Process Sheet

Customer	: CU-DAR001 Dart Helicopters Services		Drawing Name	: PANEL-W/O ROTOR BRAKE	
Job Number	: 43177		Part Number	: D38211	
Estimate Number	: 13583		Drawing Number	: D38211 UNDER REVIEW	
P.O. Number	:		Project Number	: IN0002	
This Issue	: 04/11/2008 S.O. No. :		Drawing Revision	: A UNDER REVIEW	
Prsht Rev.	: NC		Material	: MKYDEX 6185S80P362015	
First Issue	: / /		Due Date	: 14/11/2008 Qty: 2 Um: EACH	
Previous Run	: 42065				
Written By	:				
Checked & Approved By	:				
Comment	: Est. A New Issue 08/09/17 DL

DART AEROSPACE LTD	Work Order:	43177
Description: PANEL w/o Rotor Brake	Part Number:	D3821-1
Inspection Dwg: D3821 Rev: A		Page 1 of 1

FIRST ARTICLE INSPECTION CHECKLIST

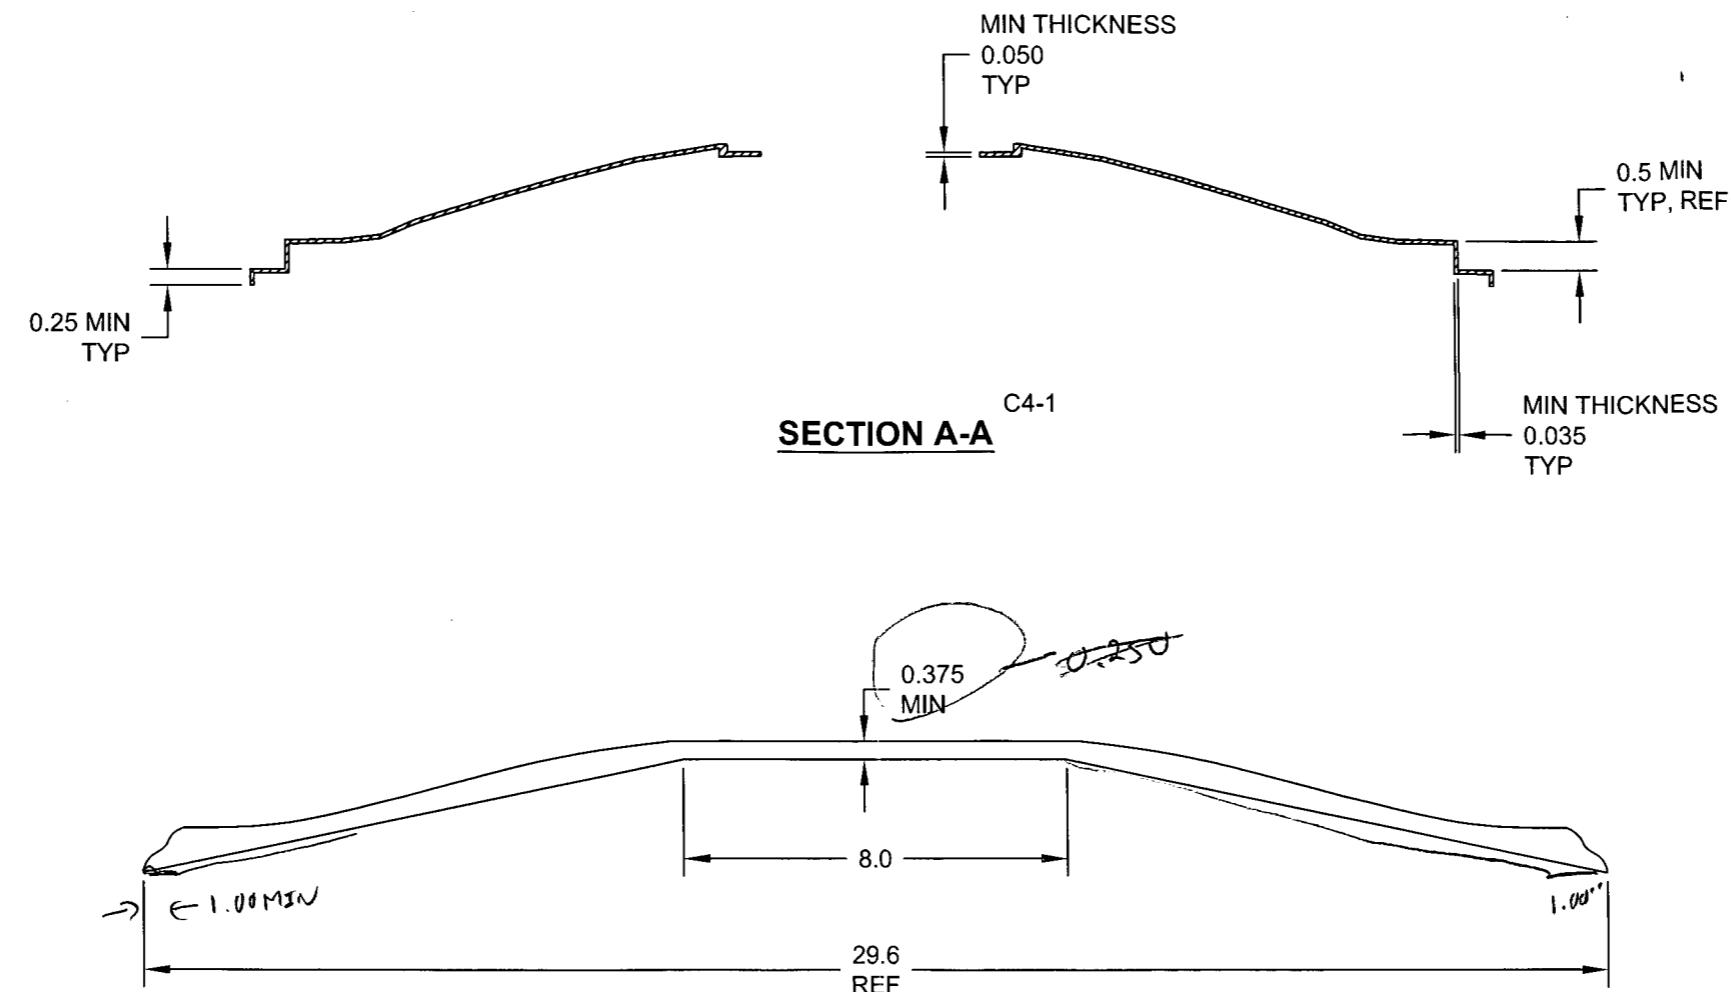
NCR:		WORK ORDER NON-CONFORMANCE (NCR)						
DATE	STEP	Description of NC Section A	Corrective Action Section B			Verification Section C	Approval Chief Eng	Approval QC Inspector
			Initial Chief Eng	Action Description Chief Eng	Sign & Date			
08-12-16	S-O	1 part scrap. Part was formed AS per mold & mold had aluminum trim rails that do not match the drawing. R-C: Tooling 1st time in use..	1051012	→ Scrap & destroy → remove aluminum rails on mold.			1051012	08-12-16

Drawing Dimension	Tolerance	Actual Dimension	Accept	Reject	Method of Inspection	Comments
0.040	Min.	0.061	—			20.08" mat'l
29.5 (Ref)	+/- 0.100	30.25	✓			Revise dim.
27.5 (Ref)	+/- 0.100	28.125	✓			Revise dim.
31.8 (Ref)	+/- 0.100	31.5	—			Revise dim/should not be ref
3.0 (Ref)	+/- 0.100	3.0	✓			
100" Typ.	+/- 0.01/-0.25	0.80	—			
2.2 (Ref)	+/- 0.100	2.2	—			Should not be ref
4.6 (Ref)	+/- 0.100	4.75	—			Revise dim/should not be ref
6.1 (Ref)	+/- 0.100	6.1	—			
0.7 Typ.	Min.	0.625	✓			Revise dim (will achieve 2.2)
19.0 (Ref)	+/- 0.100	19.0	—			Should not be ref.
20.5 (Ref)	+/- 0.100	20.500	✓			4.6

Drawing Dimension	Tolerance	Actual Dimension	Accept	Reject	Method of Inspection	Comments
1.4 (Ref)	+/- 0.100	1.4	✓			
1.9 (Ref)	+/- 0.100	2.0	✓			Revise dim
2.5 (Ref)	+/- 0.100	2.55	—			
31.2 (Ref)	+/- 0.100	30.875		✓		Revised dim/should not be ref.
0.25 typ	Min	0.3	✓			
0.050	Min	0.055	✓			
0.5	Min	0.53	—			
0.035	Min	0.052	✓			
0.375	Min	0.380	✓			
8.0	+/- 0.100	8.0	—
